**Town of Londonderry Planning Board**  
**268B Mammoth Road - Moose Hill Conference**  
**Agenda**  
**February 11 , 2026**  
**7:00 p.m.**

**RE:** The Planning Board will hold a public hearing on an application for formal review of a subdivision to permit an organic waste processing facility in the Gateway Business (GB) district at 162 Litchfield Road (Map 14 Lot 39). Zoned Gateway Business (GB), PurposeEnergy-Londonderry, LLC (applicant), Nicholas F Codner Trust 2012 (owner).

**RE:** The Planning Board will hold a public hearing on an application for formal review of a site plan and conditional use permits to permit an organic waste processing facility in the Gateway Business (GB) district at 162 Litchfield Road (Map 14 Lot 39-2). Zoned Gateway Business (GB), PurposeEnergy-Londonderry, LLC (applicant), Nicholas F Codner Trust 2012 (owner).

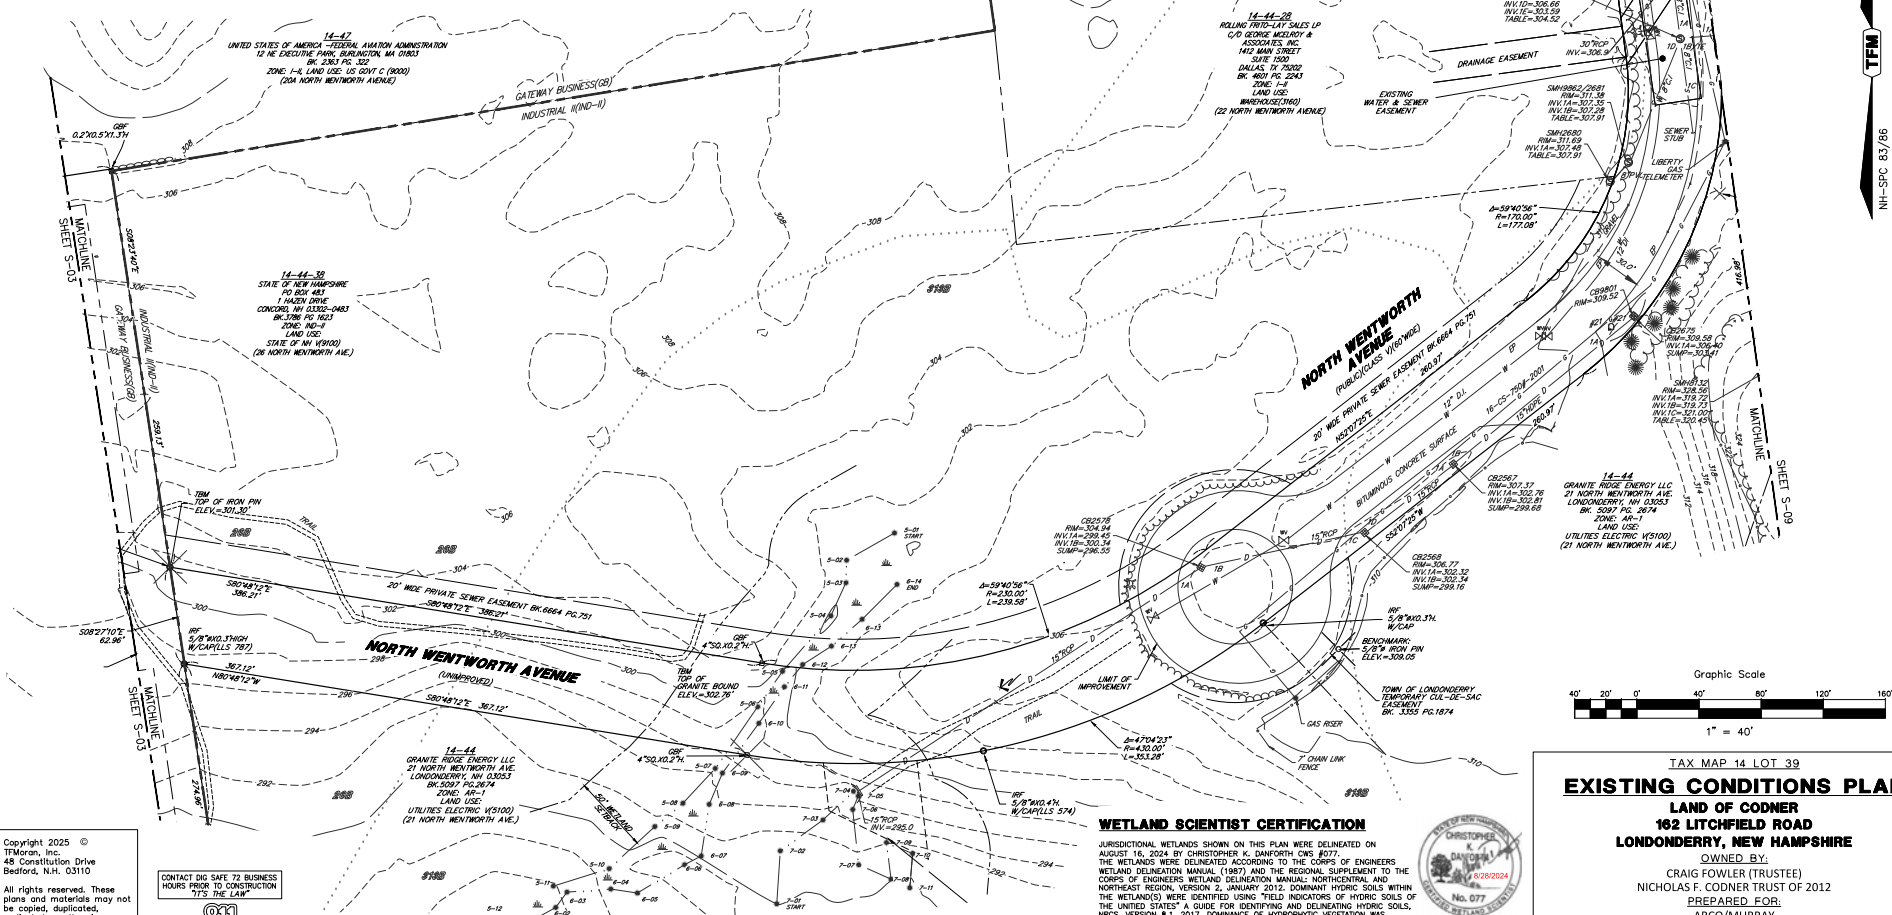
5. The existing conditions plan sheet SUB-8 indicates a 15" stormwater pipe outlet exists from the stormwater system of Litchfield Road to a swale near the westerly property line on the subject property, but the revised plans do not indicate an existing drainage easement in this location. As noted previously, it is our understanding that the Town typically requests easements or flowage rights for maintenance purposes when existing roadway runoff discharges through adjacent properties.. We recommend a drainage easement or flowage rights be provided for the existing stormwater system as acceptable the Department of Engineering and Environmental Services.

<b>TFM</b>	Civil Engineers Structural Engineers Traffic Engineers Land Surveyors Landscape Architects Scientists		48 Constitution Drive Bedford, NH 03110 Phone (603) 472-4488 Fax (603) 472-9747 www.tfm.com	
	18252-02	DR CK	FB CADFILE	D-22

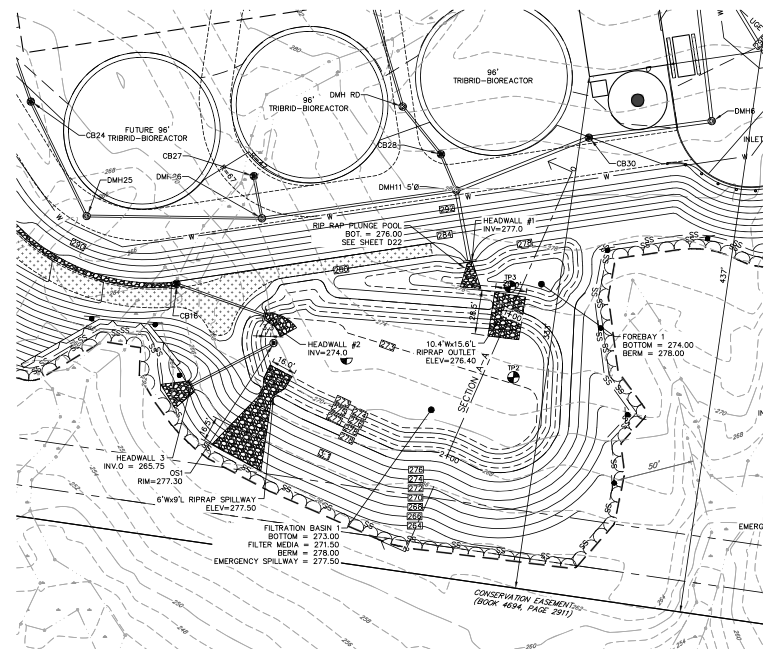
- d. The outlet structure design on sheet D-22 notes a 3'x3" galvanized steel grate in the elevation view that conflicts with other detail information that notes different sizes for the top grate. Also, detail does not properly indicate the elevations for C and B for filtration basin #1 consistent with the stormwater report. Please review and revise accordingly.
